STAINING_VILLAGE
SW_REMEDIAL_WORKS

GENERAL_ARRANGEMENT
EXISTING_ISSUES_SHEET_2_OF_2

Drawing Number:
TS18015-002

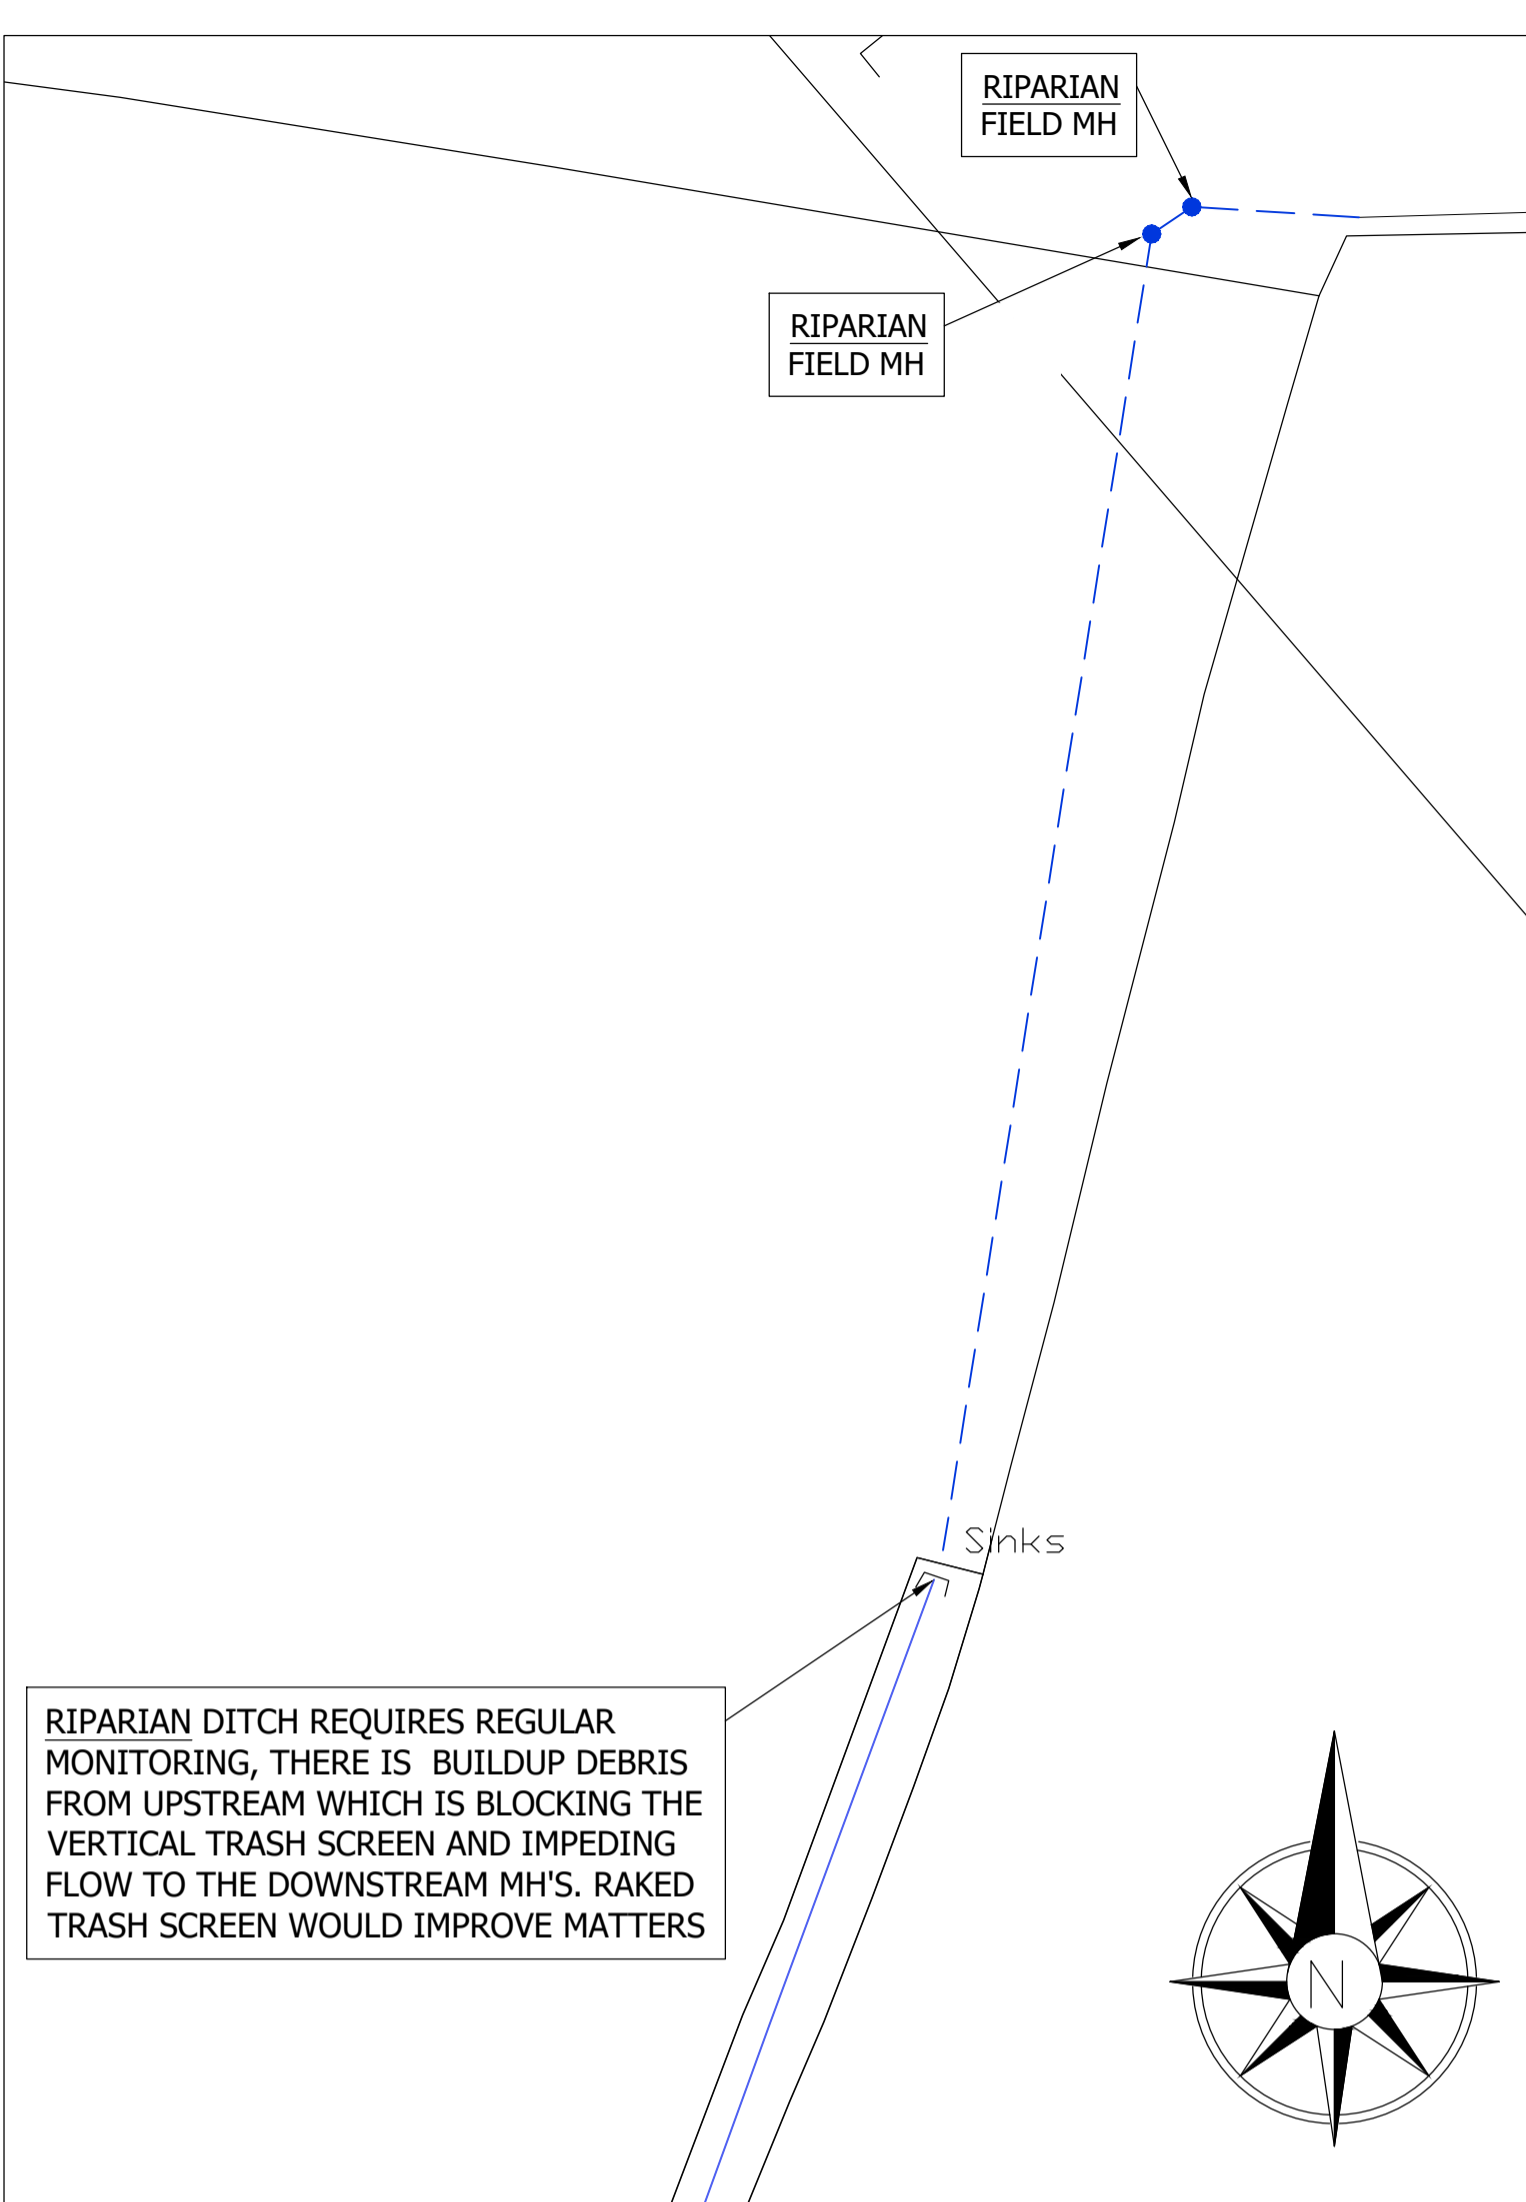
RIPARIAN HEADWALL REQUIRES RAKED TRASH SCREEN

RIPARIAN HYDROBRAKE CHAMBER REQUIRES MONITORING

RIPARIAN 'A N OTHER' MAINTENANCE & MANAGEMENT CO. BASIN POORLY MAINTAINED, HEADWALLS REQUIRE CONCRETE REPAIR MAINTENANCE AND RAKED TRASH SCREENS INSTALLED, HEADWALL APRONS REQUIRE DE-SILTING AND CLEARING OF FOLIAGE.

RIPARIAN SHORT LENGTH CULVERT, NO TRASH SCREENS - FORMER FIELD ENTRY POINT

RIPARIAN DITCH REQUIRES REGULAR MONITORING, THERE ARE A NUMBER OF BLOCKAGES WITH DEBRIS BUILDUP IN CHANNEL NEEDS TO BE CLEARED AND KEPT CLEAR TO MAINTAIN THROUGH FLOW

RIPARIAN DITCH AT THE BACK OF NUMBER 9 KINGS CLOSE NEEDS, REMOVAL OF FALLEN TREE, DIGGING OUT, DE-SILTING AND THE PIPE WORK JETTING THROUGH AS IT IS 75% FULL

RIPARIAN TWIN HEADWALL FLAP VALVE NOT FIT FOR PURPOSE CONSIDER REPLACEMENT

RIPARIAN OR UU? MH (18)

RIPARIAN OR UU? MH (13) REQUIRES REGULAR MONITORING TO ENSURE SW THROUGH FLOW

RIPARIAN MH (12A) REMEDIAL WORK TO BENCHING

RIPARIAN MH (12B) REMEDIAL WORK TO BENCHING

RIPARIAN DITCH REQUIRES REGULAR MONITORING, THERE IS BUILDUP DEBRIS FROM UPSTREAM WHICH IS BLOCKING THE VERTICAL TRASH SCREEN AND IMPEDING FLOW TO THE DOWNSTREAM MH'S. RAKED TRASH SCREEN WOULD IMPROVE MATTERS
